--- ADDENDUM #1 ---

Issued March 13, 2025 to all bidders

Town of Wolfville
 Kent Avenue
 New Sidewalk

Tender Form (ADDENDUM #1)
 WOL004-2025

SIDEWALK CROSS SECTION E/5

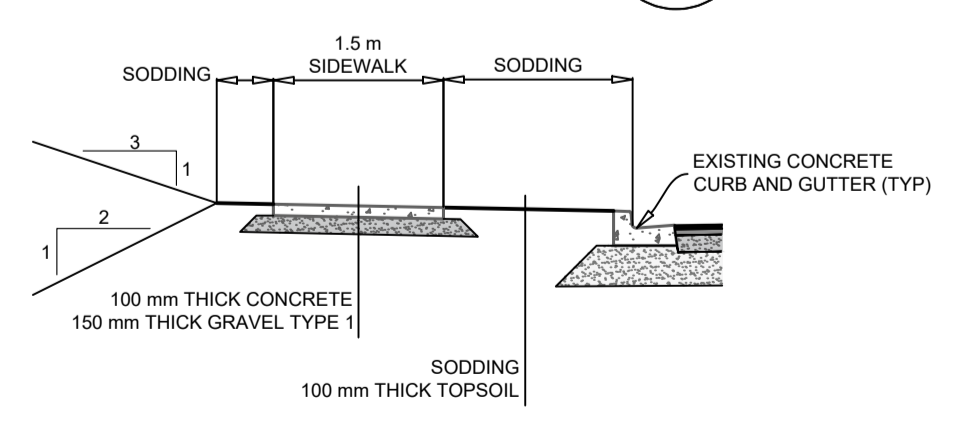
- a. **Clearing has been removed as a pay item.**
- .4 What is the required thickness of topsoil and sod?
 - a. **See detail E-5 on sheet C-PP05.**
- .5 There is a pay item for a new sign base, however, it is not noted on the drawing the location of the new sign. Is there an existing sign post and base to be removed? There is also no detail provided for the proposed new sign base, will a typical precast base kit and telespar sign post be acceptable?

.9 No detail has been provided showing gravel thickness under the sidewalk. Further to question 6 above, if the gravel pay item is not intended for gravel under the sidewalk, please confirm the required thickness so this cost can be quantified and appropriately carried in our bid.

a. See detail E-5 on sheet C-PP05.
